SERVICE BULLETIN

No. 257

Piper Aircraft Corporation

<u>Subject:</u>	Piper Navajo Modifications (see below)
<u>Models Affected:</u>	PA-31 Navajo
<u>Compliance Date:</u>	Prior to but not later than the next 50 hours of operation
<u>Availability of Parts:</u>	Piper Dealer
<u>Expiration Date of Warranty:</u>	March 31, 1968

SECTION I

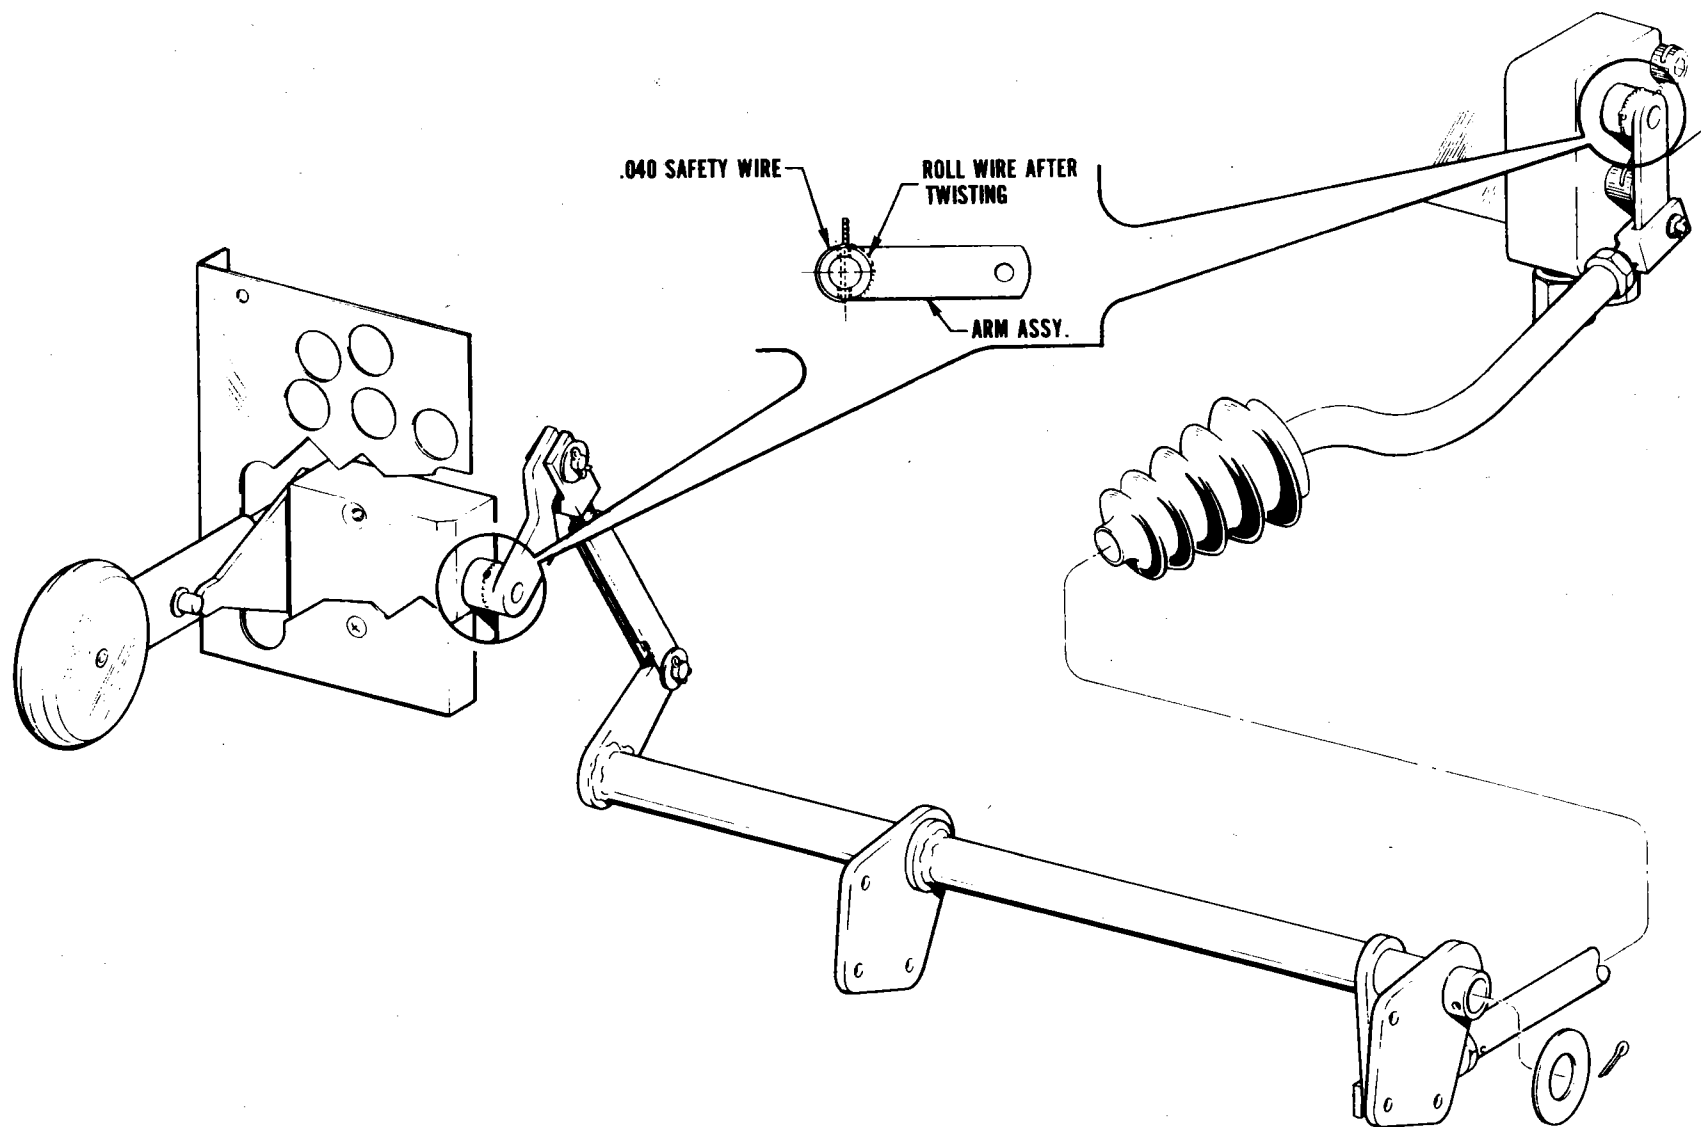
<u>Subject:</u>	Securing of Roll Pins on Landing Gear Selector Mechanism
<u>Serial Numbers Affected:</u>	31-2 to 31-49 incl., 31-51, 31-53, 31-54, 31-56, 31-57
<u>Reason For Bulletin:</u>	Securing of landing gear selector mechanism roll pins with .040 steel safety wire.
<u>Material Required:</u>	.040 Steel Safety Wire
<u>Installation Instructions:</u>	See sketch attached
<u>Warranty Labor Allowed:</u>	One (1) Hour
